SUBJECT: DuPage Airport  
West Chicago, Illinois  
DuPage County  
Illinois Project Number: DPA-4300  
SBG Project Number: 3-17-SBGP-XX  
Contract No. DU081  
Item No. 05A, 6-10-2016 Letting  
Addendum A

## NOTICE TO PROSPECTIVE BIDDERS

05A  
6-10-2016 LETTING

## CONSTRUCT WEST END PERIMETER ROADWAY

project	88849	contract	DPA-4300
drawing	<b>G-002</b>	rev.	-
sheet	of	sheets	file

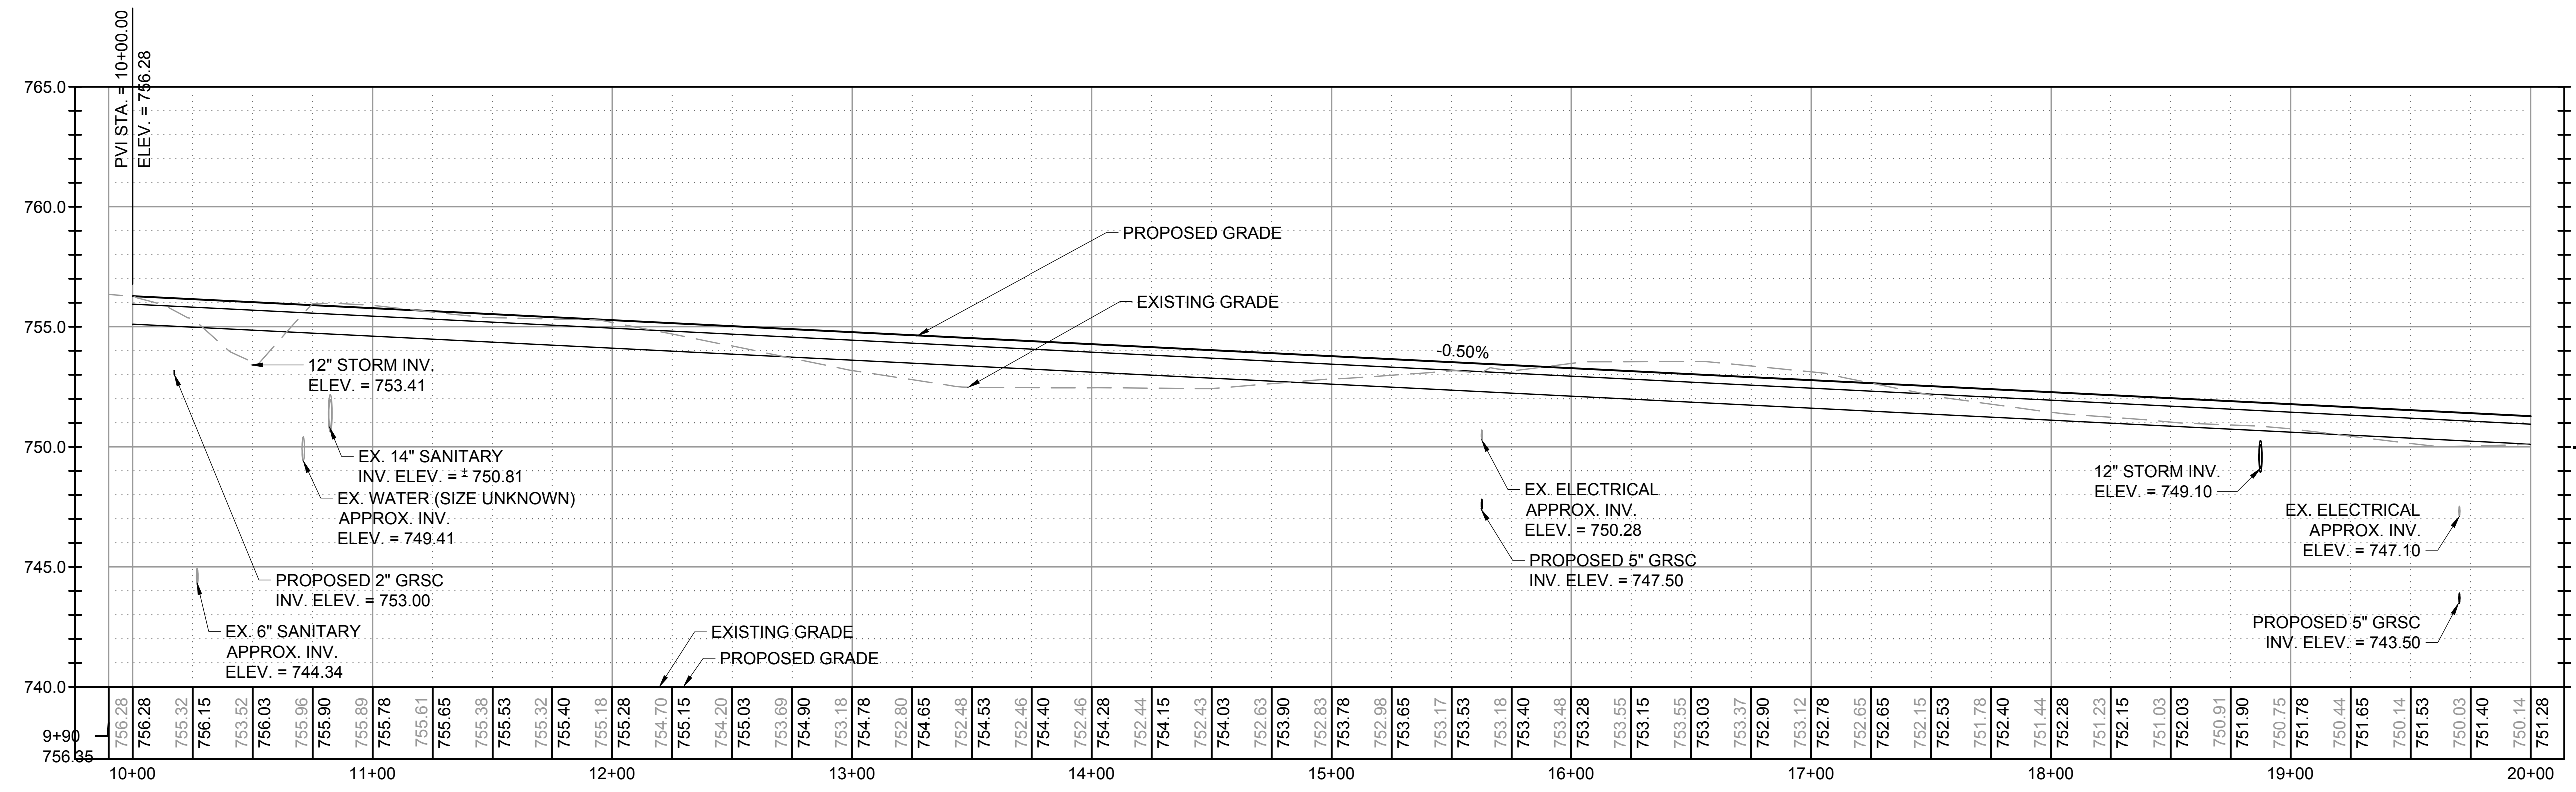
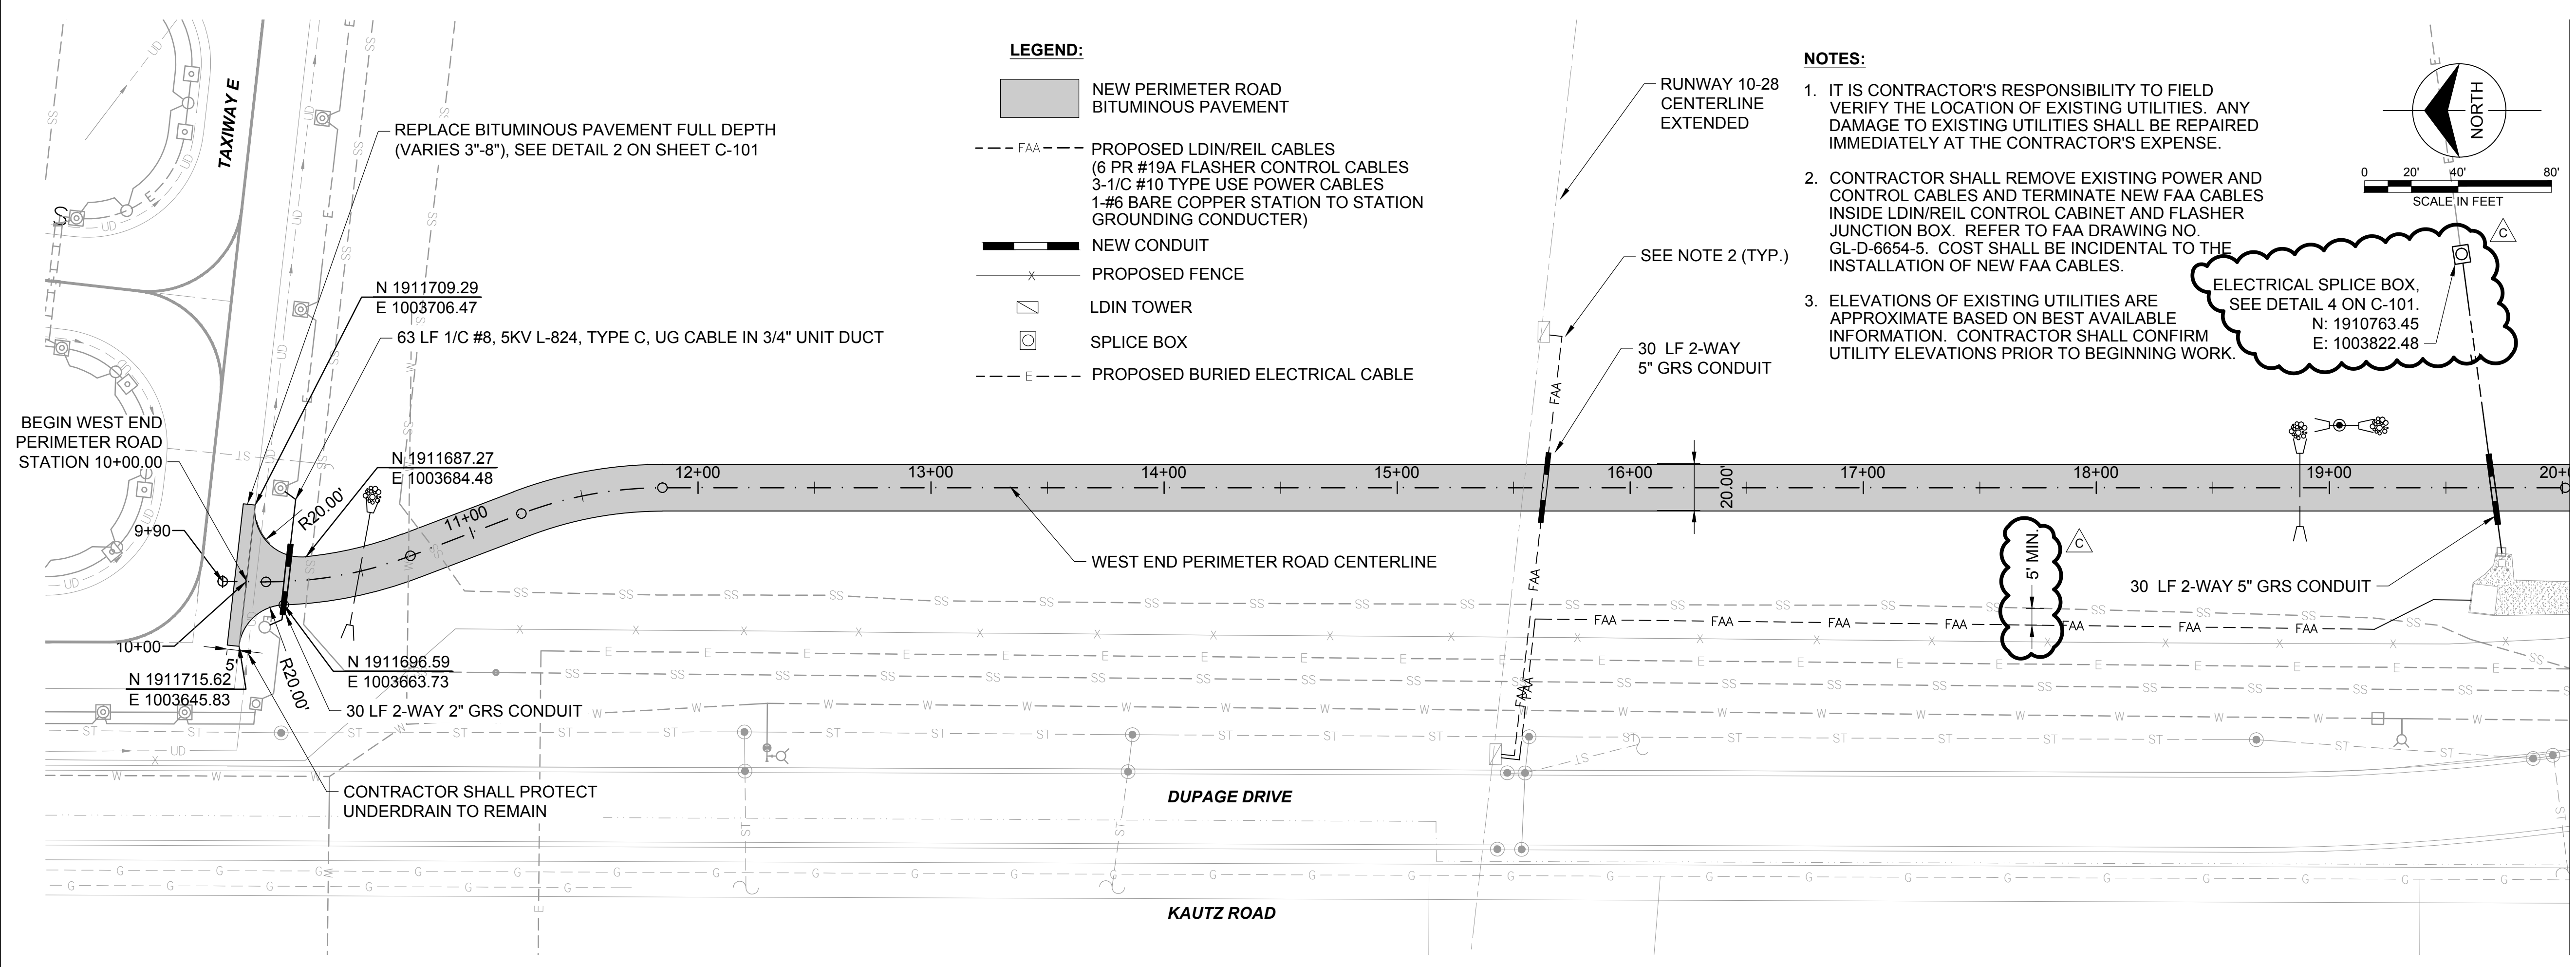
10. G-002
  - Revised summary of quantities and updated index to reflect additional sheet.
11. CS-101
  - Additional dimension provided to clarify layout of FAA Cable. Splice box detail callout and coordinates provided.

project	88849	contract	DPA-4300
drawing	<b>CS-102</b>		
sheet	of	sheets	
file

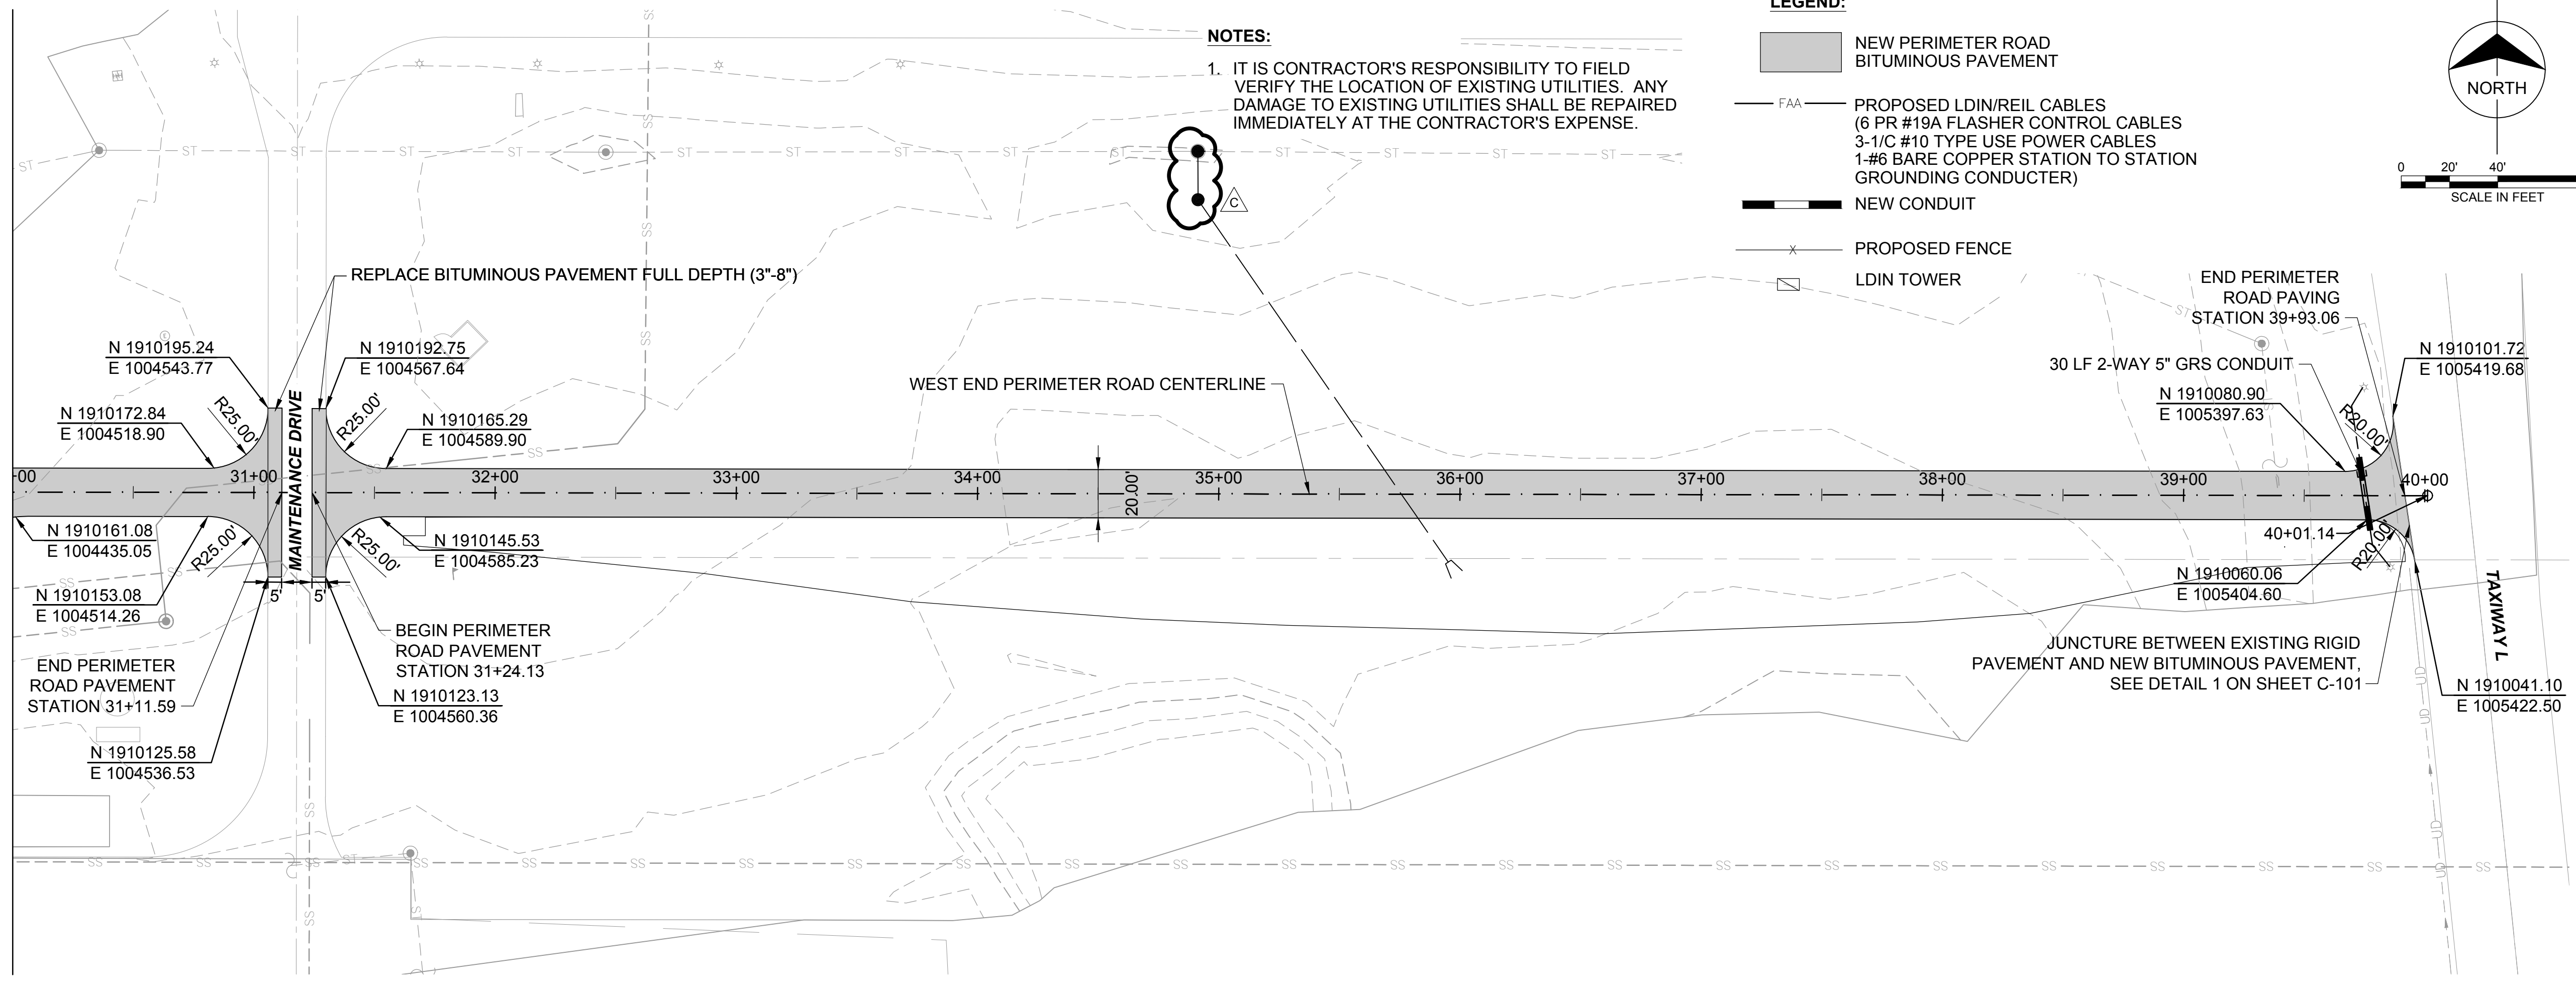
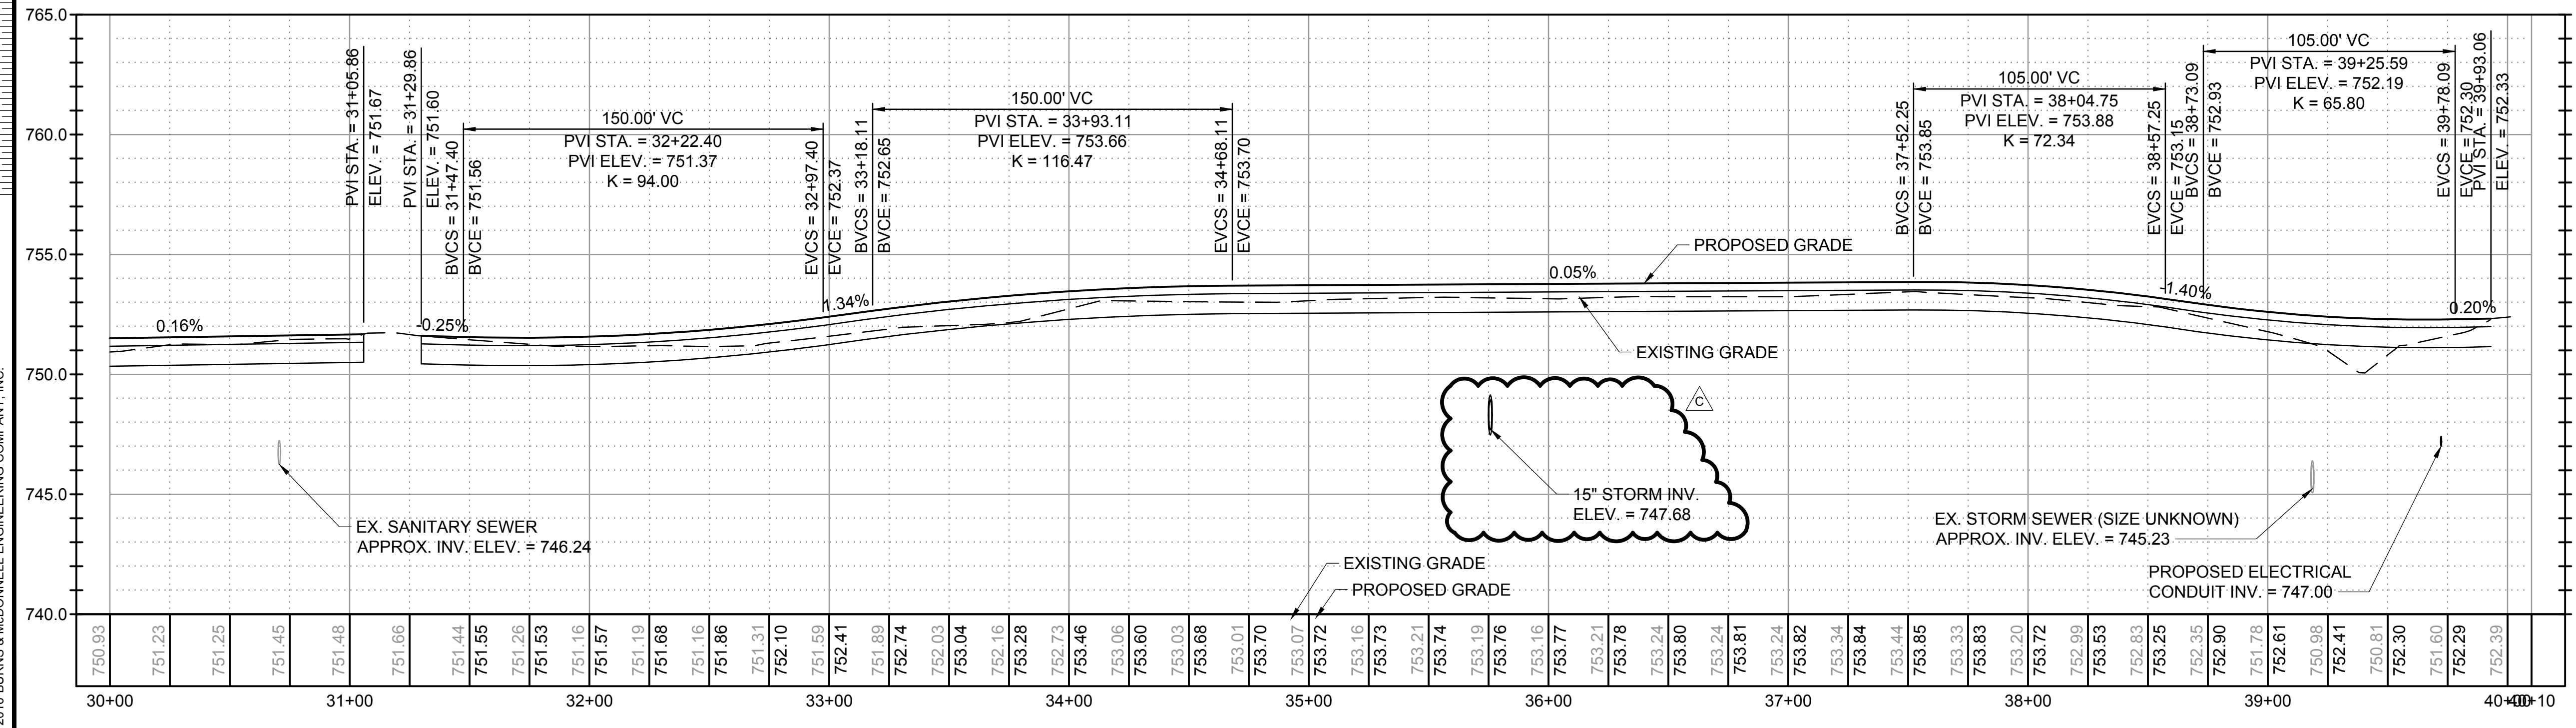
12. CS-102, CS-103, CS-104
  - Revised plan and profile to reflect additional storm sewer
13. CG-101
  - Updated FAA cable and splice box location. Addition of soil borings and topsoil thickness.
